Access Compliance Report

Public Rights-of-Way

Intersection ID: 14022	Main Street: HAWKINS_ST	Cross Street: W_WORTHINGTON_AV	Location: S
ADA ID: 807BE45B3D9C	Ramp Type: PerpDiag	Initial Pass/Fail: Fail	Overall Compliance: No
		Severity Score: 1.25

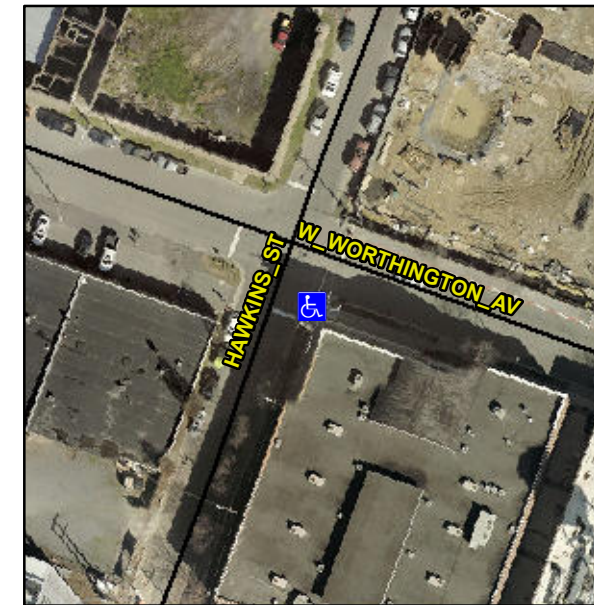
Surveyor Notes:

Not Found, R304.5.3

Remove & Replace Curb Ramp With Two New Directional Ramps or Equivalent.
